**FINDINGS OF FACT
FLORENCE PLANNING COMMISSION
Exhibit "A"**

Application: PC 24 22 DR 07

Proposal: A Design Review application for an e-waste recycling and hazardous waste storage building.

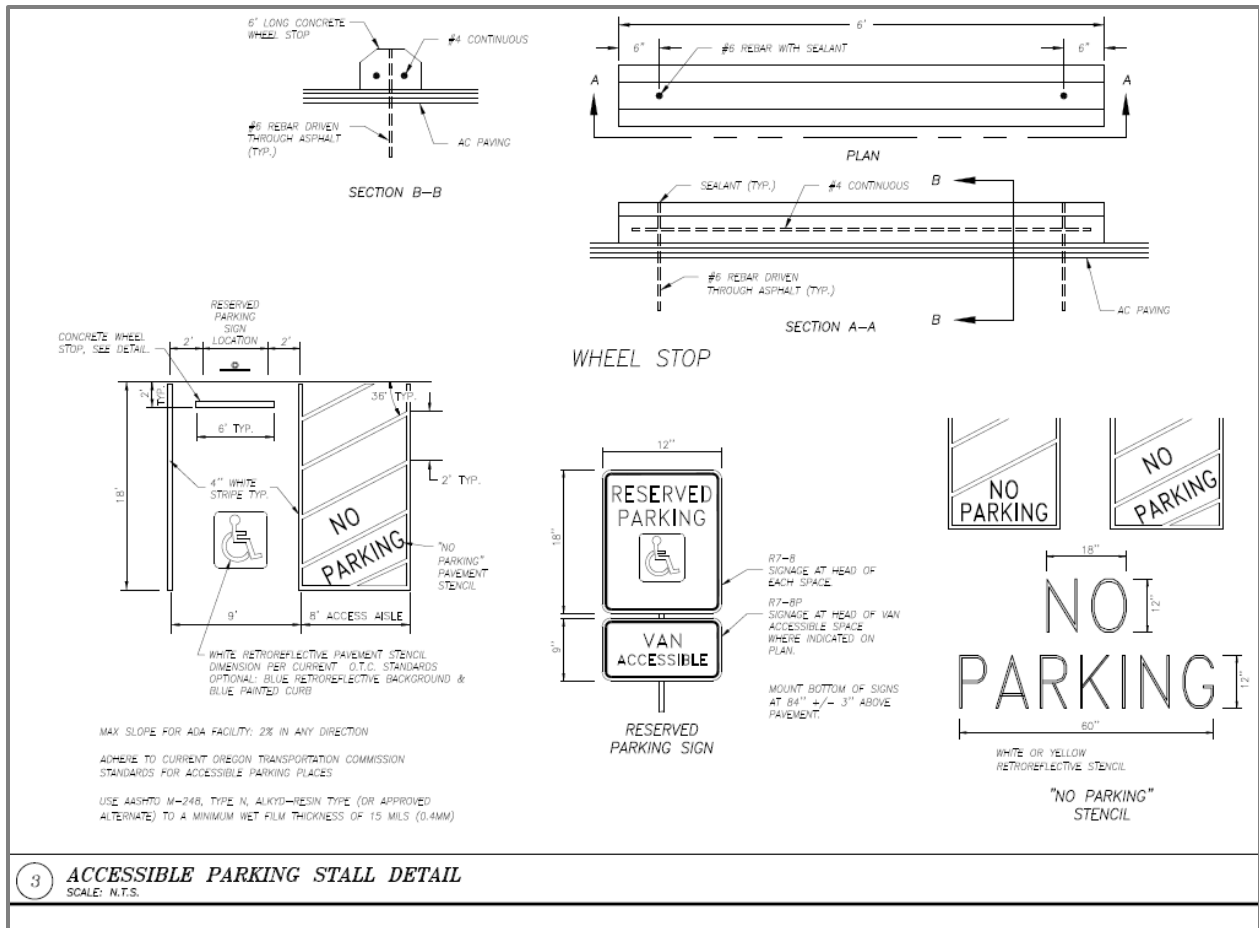
The ADA parking stall is proposed to have dimensions of 9 feet wide by 18 feet long with a 6 foot wide access aisle to the south. The proposed striping is single line striping 4 inches in width. The specific details of the ADA parking stall can be seen on Sheet C1 and C2 of Exhibit C.

In accordance with this Code section, the ADA parking stall and access aisle shall be a minimum 19 feet in length and shall have 2 foot wide double line striping 2 feet on center. Alternatively, meeting minimum ADA accessible guidelines for dimensions is acceptable. **(Condition 4.1)**. The parking areas proposed on Sheet C1 indicates the total length of the parking area is 22 feet in length. Adequate space is available to accommodate the additional 1 foot of parking stall length, Minimum parking stall width is 9.5 feet, compared to the 9 feet proposed. The 9 feet in width proposed is determined to be acceptable as minimum ADA parking stall width is 96 inches with the

Maximum slope allowed in accordance with ADA standards is 1:48, or approximately 2%. The access aisle is indicated to have a 1.8% slope. The ADA parking stall itself does not have a slope indicated, but Sheet C2, detail 3 states that max slope for the ADA facility in any direction is 2%. This criterion is met.

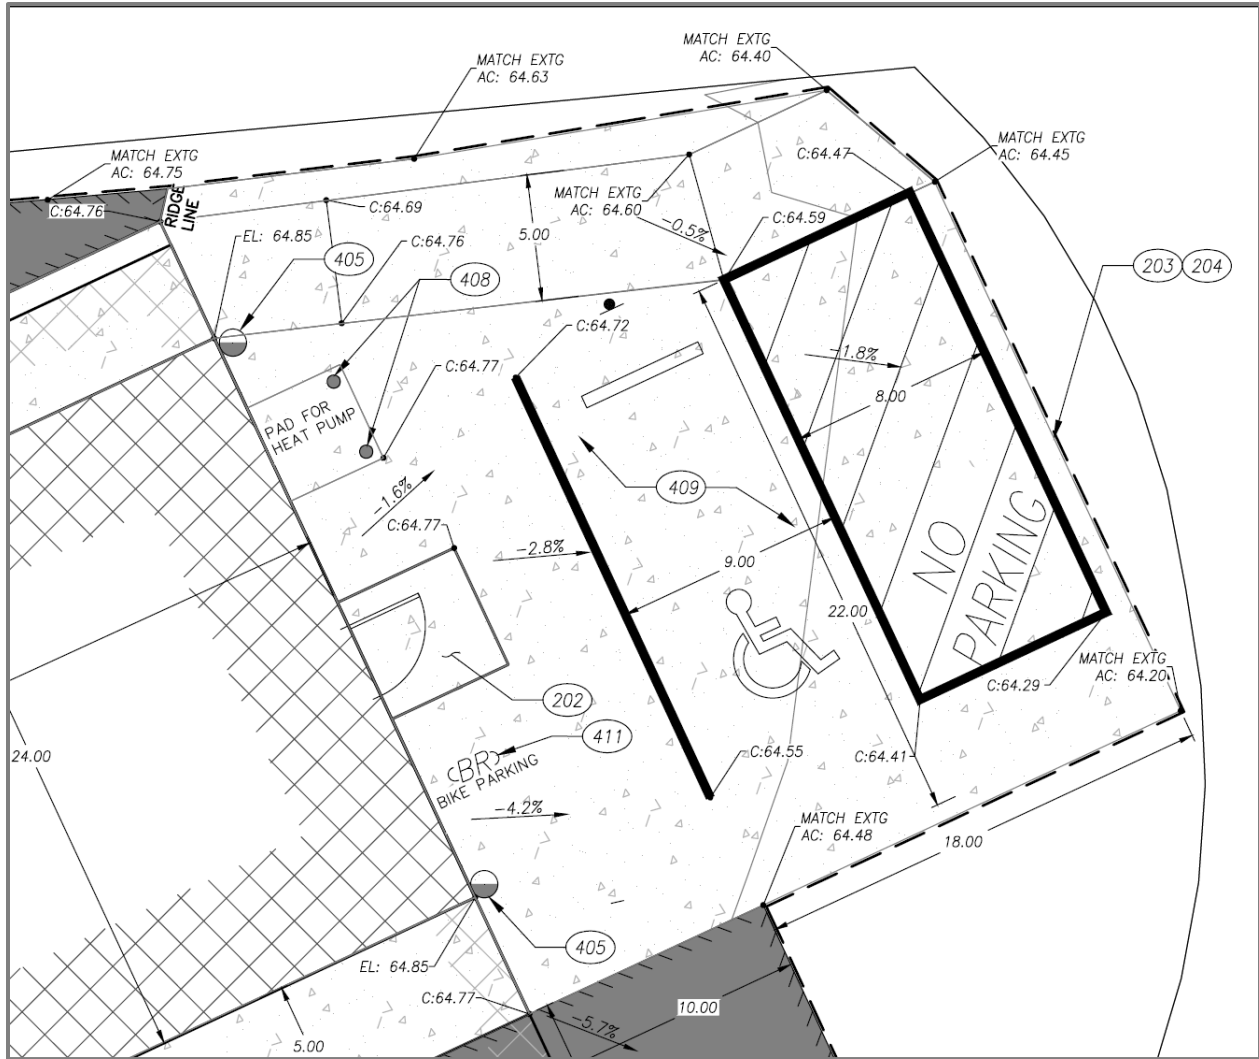
A 6-inch wheel stop is proposed to prevent vehicle encroachment into the ADA accessible walkway accessing the building.

The ADA parking stall has been conditioned to meet minimum Code criteria, unless dimensions meet the requirement of Section F above and has no other deficits.

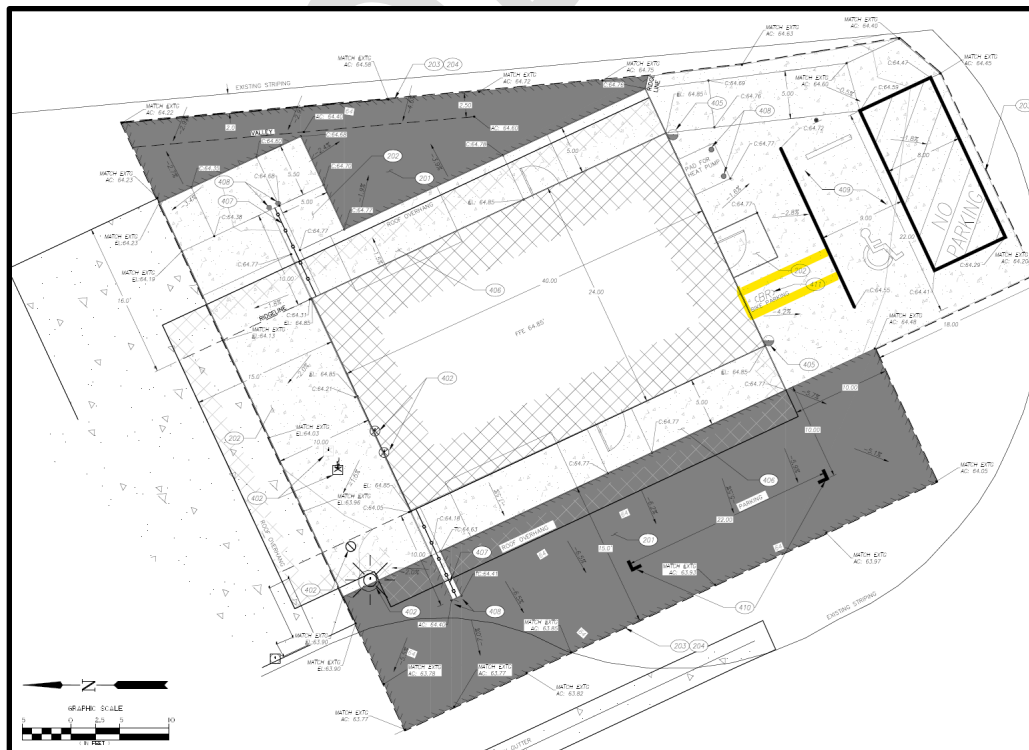
The standard parking space is proposed to be a parallel parking stall west of the building. The parking stall is proposed to have dimensions of 22 feet in length by 10 feet in width. A 5-foot wide pedestrian walkway is proposed between the parking stall and the building. There is a railing and bollard proposed at the northwest corner of the building serves to guide vehicles around the walkway and protect pedestrians, while also maintaining unobstructed space to drop-off recyclables. This meets minimum standards for pedestrian safety and separation from vehicles. The standard parking stall meets Code criteria.
